SERVICE 		4
		B9800016

SB, 365, Carburettor, 1998-06

Zama C3M-EL2B
Zama C3M-EL8A

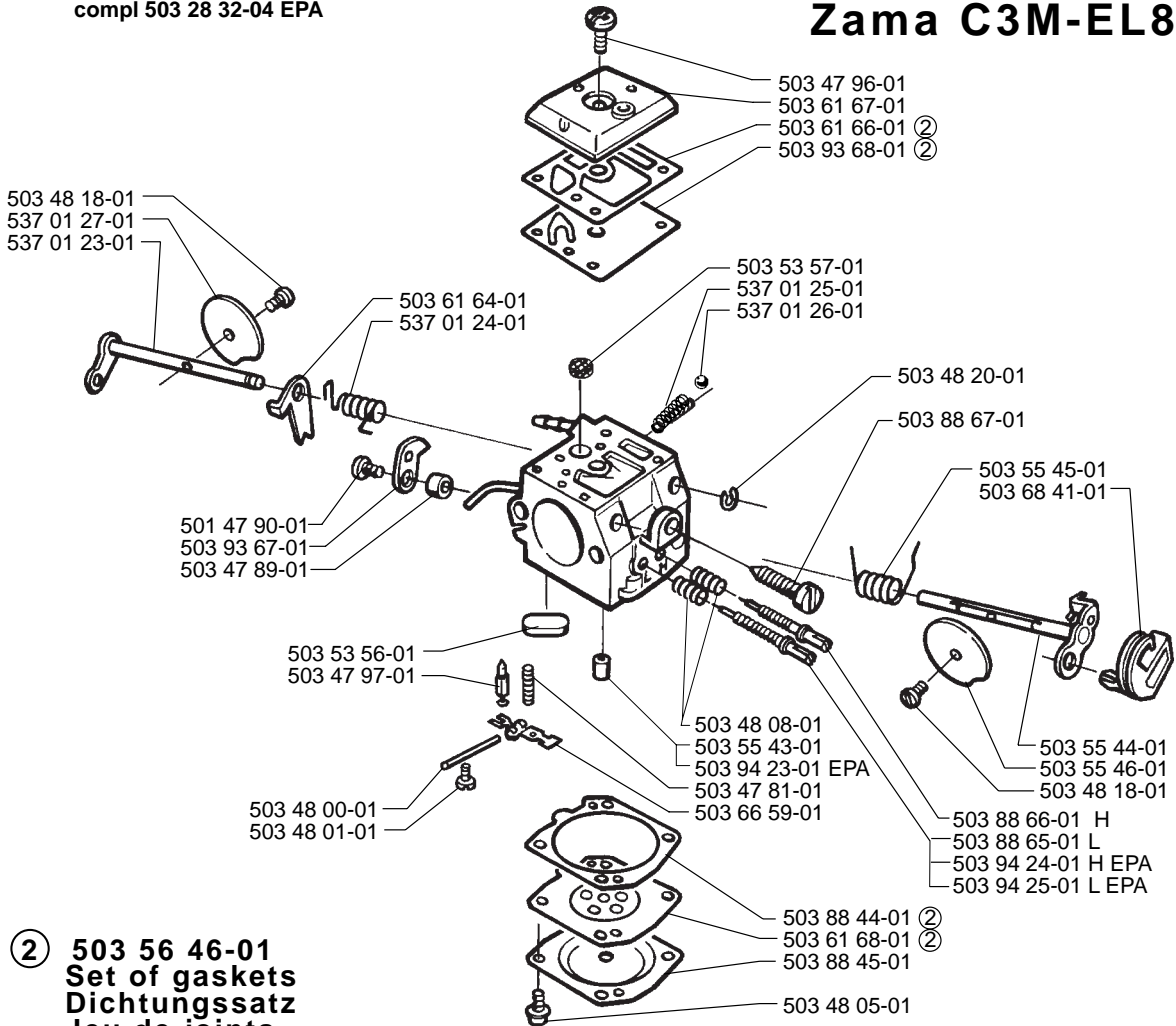
To lock the choke shaft in closed position, a spring-loaded ball is mounted in the carburettor housing. This implies a new carburettor housing and a number of new parts. The carburettor is also given a new description.

Parts with description EPA only apply to carburettor C3M-EL8A. Previous carburettors can not be rebuilt to the later type of choke valve.

When changing complete carburettor, there is full interchangeability.

Introduced from serial number: 365 8200901
